UNITED STATES PATENT AND TRADEMARK OFFICE

APPLICATION NO.	FILING DATE	FIRST NAMED INVENTOR	ATTORNEY DOCKET NO.	CONFIRMATION NO.
10/581,817	05/14/2007	Markus Hoffmeister	10191/4451	7185
26646 7590 05/15/2008 KENYON & KENYON LLP ONE BROADWAY NEW YORK, NY 10004				
EXAMINER DUONG, DIEU HIEN				
ART UNIT 2821		PAPER NUMBER		
MAIL DATE 05/15/2008		DELIVERY MODE PAPER

DETAILED ACTION

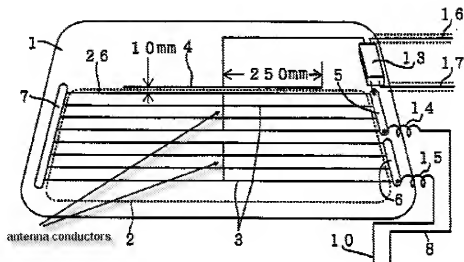
4. Claims 11-15 are rejected under 35 U.S.C. 102(b) as being anticipated by Murakami et al. (US 5,334,988), hereinafter "Murakami".

Regarding claim 11, Murakami discloses, in Figure 4 and col. 3, lines 10-17, a window-integrated antenna for a vehicle, comprising a heating conductor field (3), which is provided for FM reception and LMS reception; and at least one decoupling element (4) for the FM reception which has a high-frequency, low-resistance, and non-galvanic connection to the heating conductor field (3).

Regarding claim 12, as applied to claim 11, Murakami discloses, in Figure 4 and col. 3, lines 10-17, wherein the decoupling element (4) for the FM reception includes at least one conductor (4) situated essentially parallel to at least one boundary of the heating conductor field (3) which is not formed by a busbar (7) for the heating conductor field (3).

Regarding claim 13, as applied to claim 11, Murakami discloses, in Figure 4, wherein at least one of a length and a position of the decoupling element (4) is arranged so that a resonant impedance behavior occurs in the FM frequency range at a connection end of the decoupling element.

Regarding claim 14, as applied to claim 11, Murakami discloses, in Figure 4, wherein antenna conductors are situated in the heating conductor field essentially perpendicular to heating conductors of the heating conductor field and are galvanically linked to the heating conductors (3).

Regarding claim 15, as applied to claim 14, Murakami discloses, in Figure 4, wherein at least one of a length and a position of the antenna conductors is arranged so that a resonance behavior of the window-integrated antenna occurs at a connections end of the decoupling element in the FM range.

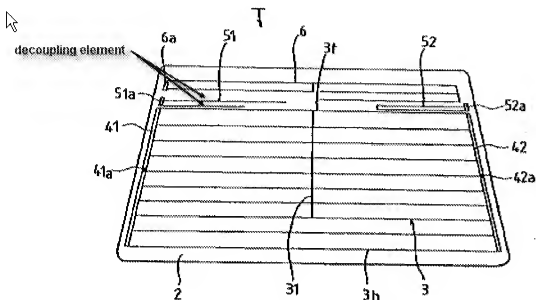
5. Claim 11 and 16-19 are rejected under 35 U.S.C. 102(b) as being anticipated by Oka (US 2004/0056810 A1).

Regarding claim 11, Oka discloses, in Figure 1 and par. [0033], a window-integrated antenna for a vehicle, comprising a heating conductor field (51), which is provided for FM reception and LMS reception; and at least one decoupling element (51) for the FM reception which has a high-frequency, low-resistance, and non-galvanic connection to the heating conductor field (3).

Regarding claim 16, as applied to claim 11, Oka discloses, in Figure 12, further comprising at least one further decoupling element (51) for a different frequency range.

Regarding claim 17, as applied to claim 16, Oka discloses, in Figure 12, wherein the decoupling element (51) for the FM reception and the at least one further decoupling element are galvanically connected at their connection ends.

Regarding claim 18, as applied to claim 11, Oka discloses, in Figure 1 and paragraph [0050], wherein the at least one decoupling element for the FM reception and further decoupling elements for the other frequency ranges are connected to a diversity switching device.

Regarding claim 19, as applied to claim 11, Oka discloses, in Figure 1, wherein a plurality of decoupling elements (51) including the decoupling element for the LMS reception are connected to a shared module carrier (7).
